**Re: Seacoast Reliability Project - SEC Docket 2015-04
Notification of Minor Construction-Related Changes
Submarine cable and Eastern Shore Landing**

LIST OF FIGURES

Newington Cable Landing and Slope Restoration

SEACOAST RELIABILITY PROJECT
 LITTLE BAY, NH
 NEWINGTON CABLE LANDING
 TOE OF SLOPE DETAIL

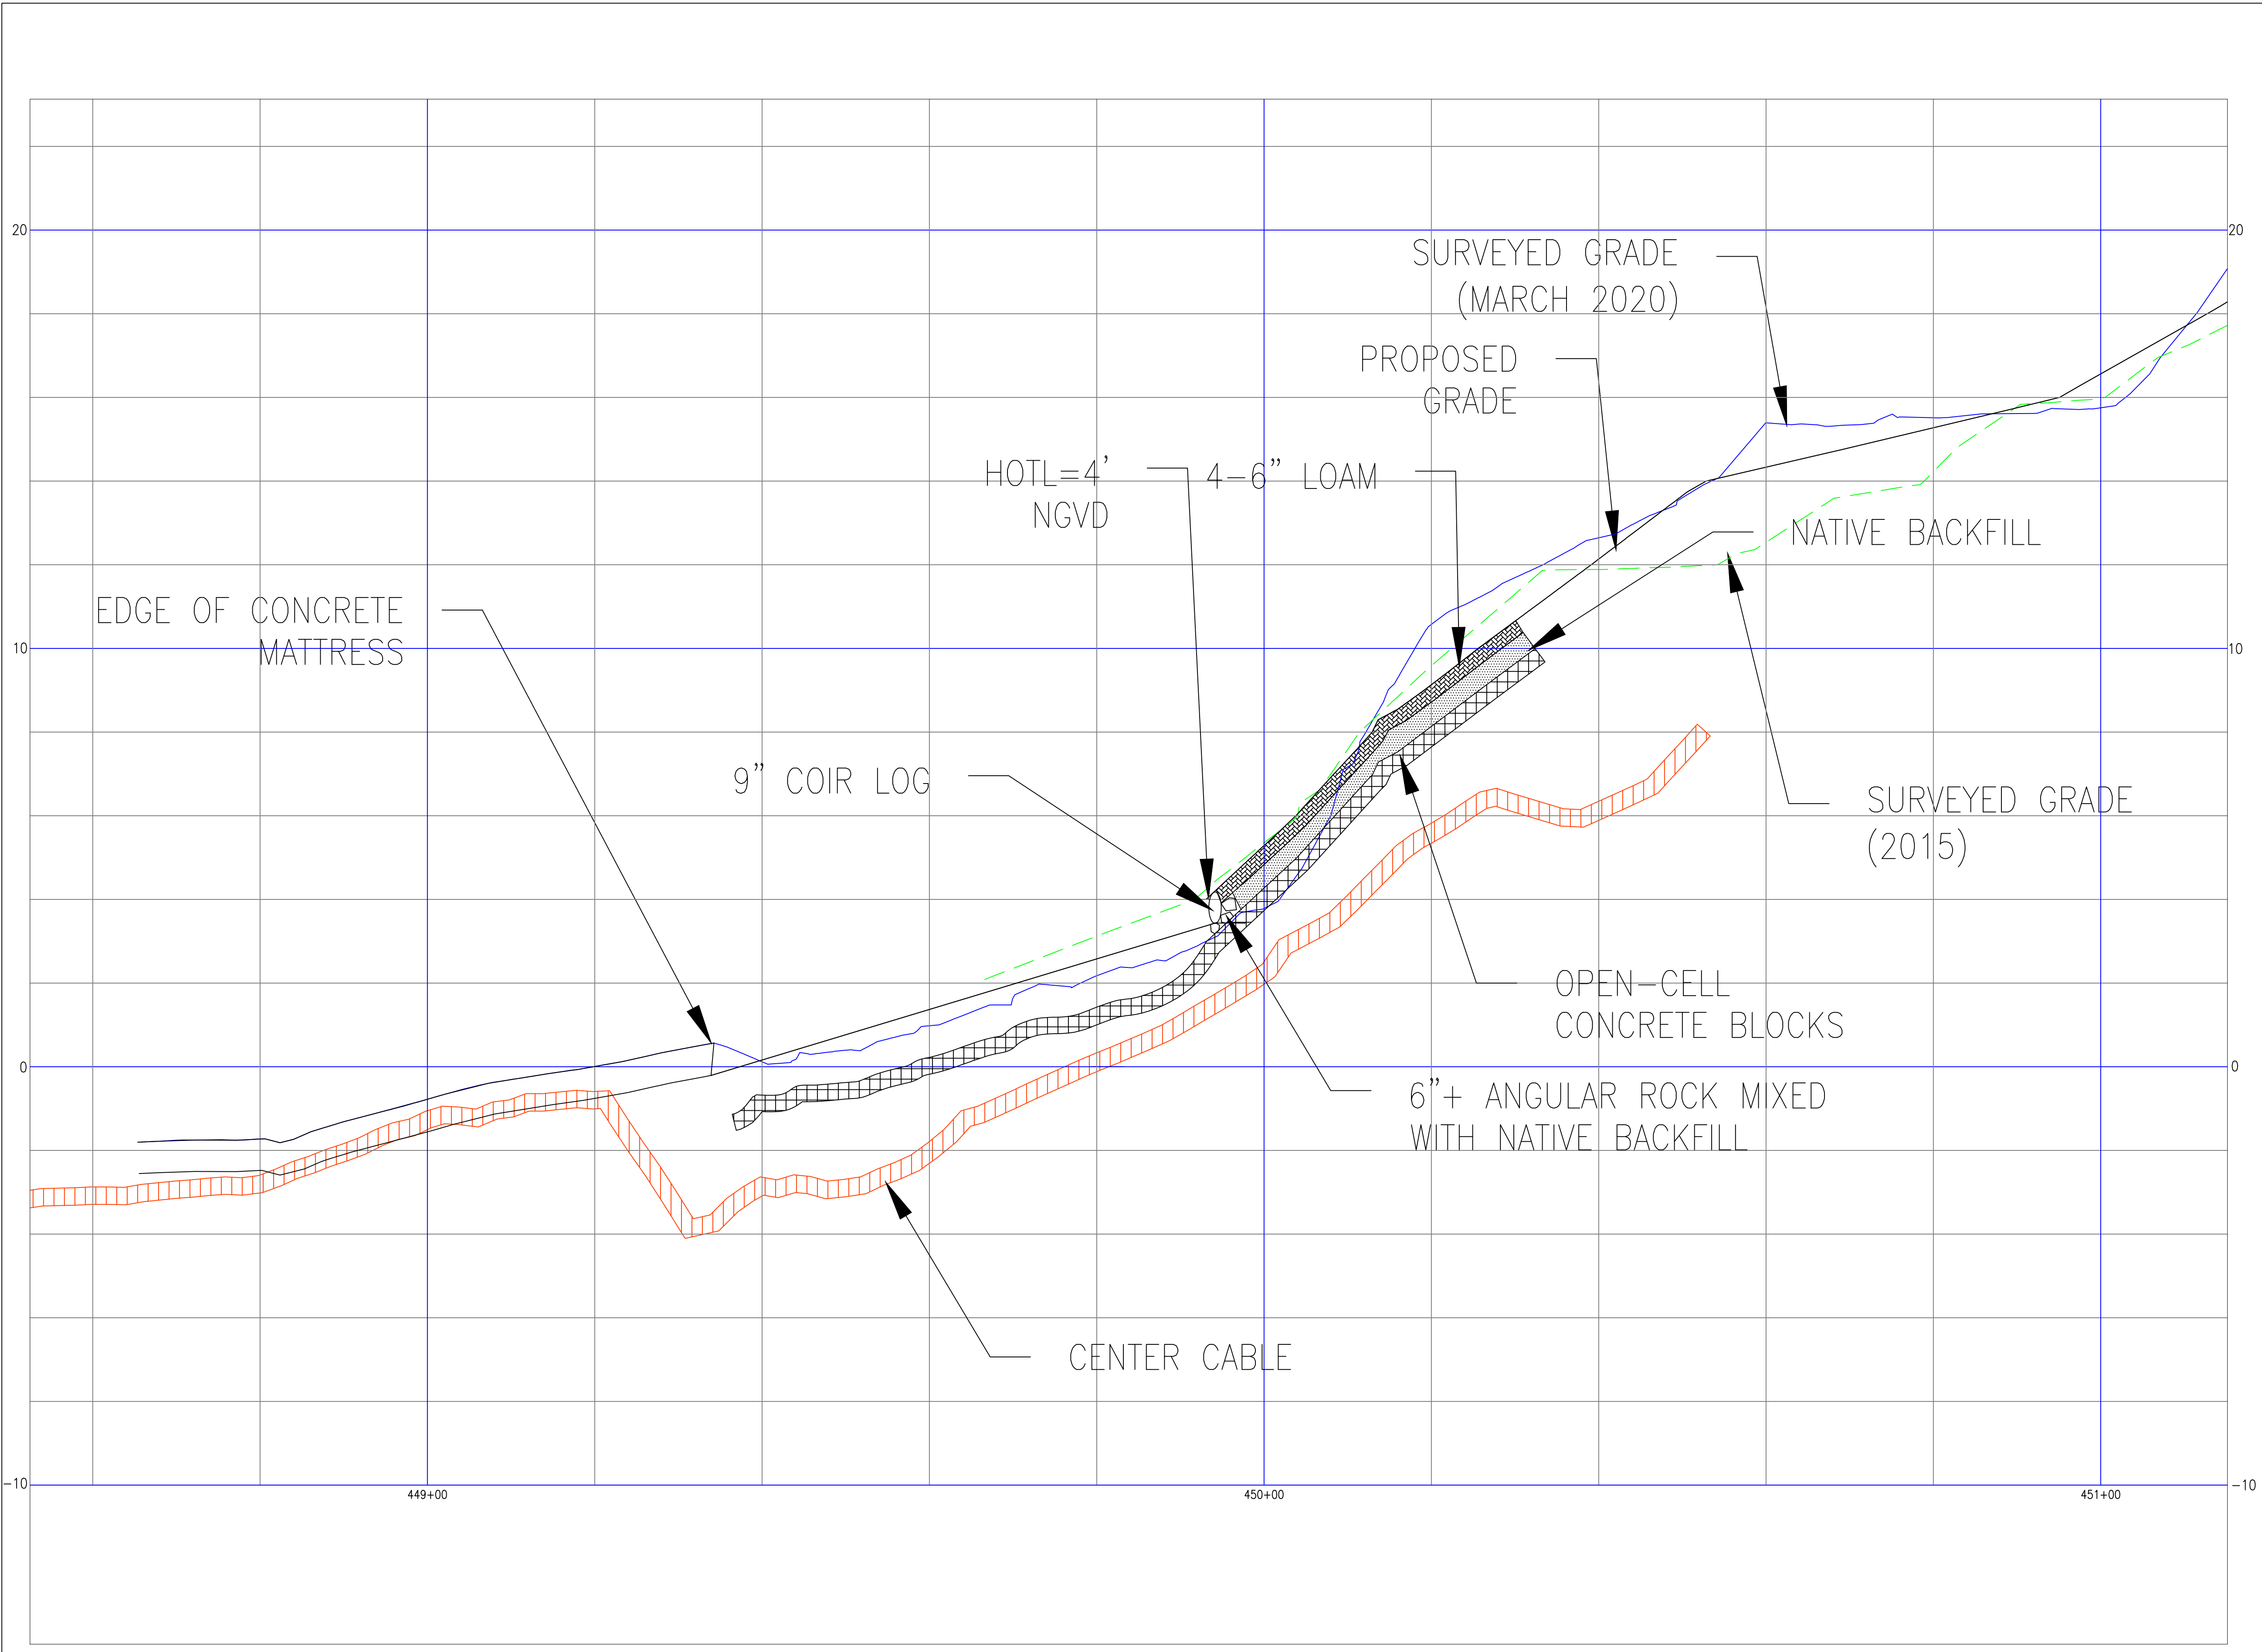
The toe of slope in the intertidal zone will be stabilized with a combination of rock and soil, similar to the shoreline restoration on the west side of the cable crossing. A 9" coir log will be installed at the intersection with the tidal flats to both stabilize the new toe and tie the work into the adjacent steep slopes as shown on Sheet 3, the Toe of Slope Detail Plan.

Figure 1 –2015 Beswick Topographic Plan

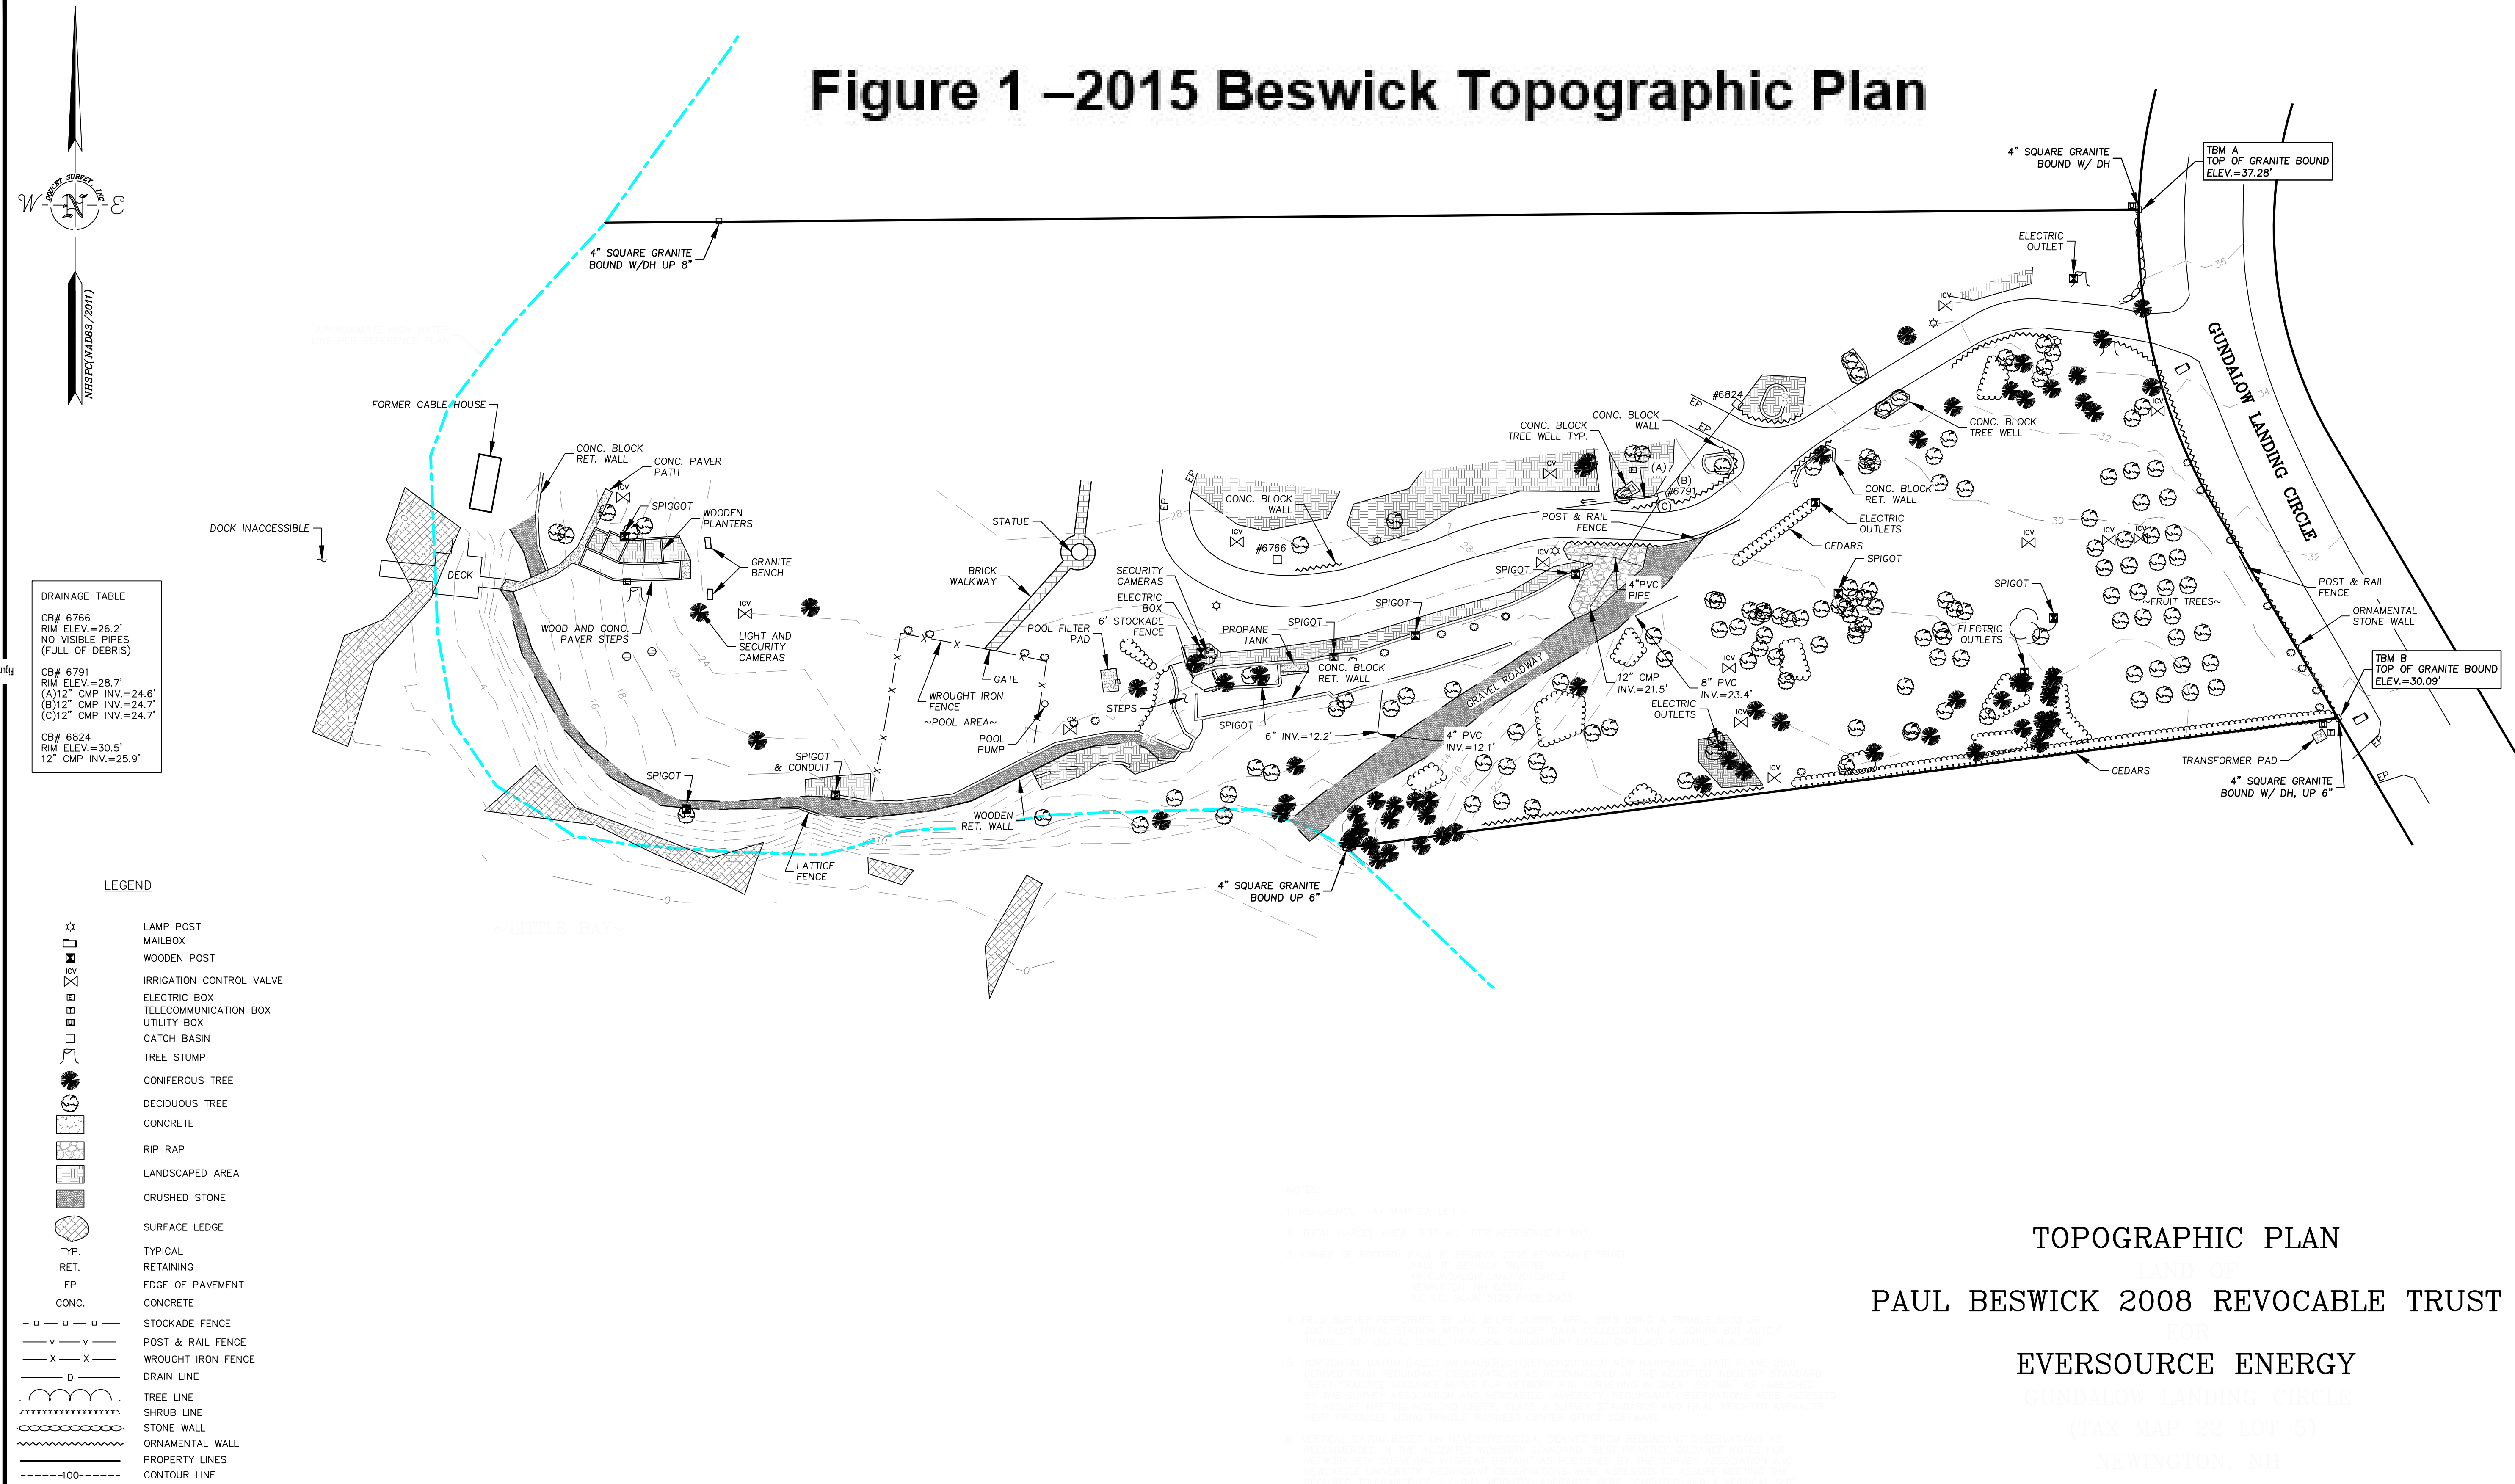
The underlying landowner has requested to review the revised final design and grading and has asked that a gravel path be restored from her driveway to as close to the shore as possible to allow cartop boat and kayak launching. The original gravel path was shown in a 2015 preexisting conditions plan (Figure 1) and preconstruction photographs provided as Attachment-2. The grades shown on Figure 1 represent the original grades; they are being used to help determine the final grades at the site.

ARMORFLEX BLOCK & UNIT SPECIFICATIONS

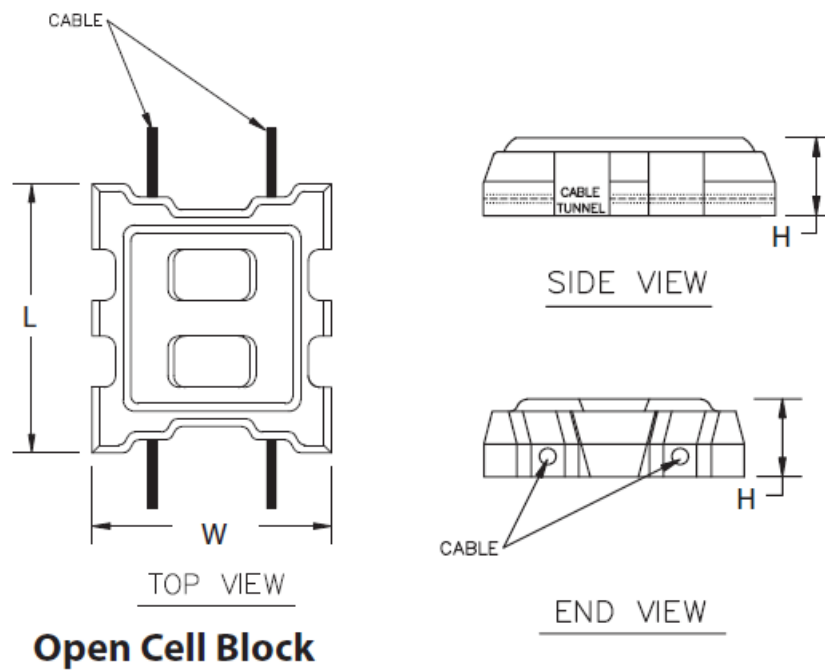
Each Armorflex block (refer to the Armorflex Specifications in Attachment-1) is 13" x 11.6" in area. The blocks are laced together with manufacturer-supplied cable to form a continuous surface. To provide sufficient protection, the blocks will extend approximately 2' beyond the edges of the outside cables. To install the additional protection, Eversource's contractors will employ similar trenching methods as were permitted for use in the nearshore area to install the submarine cables. A small excavator and loader will work sequentially from construction matting in the dry during low tide cycles. The contractors will side cast the sediments and subsequently lay the concrete blocks by hand at depths that allow for a target depth of 12" of sediment backfill over the blocks. Disturbed areas will be backfilled at the end of each low-tide work cycle and turbidity curtains will be installed surrounding the work area.
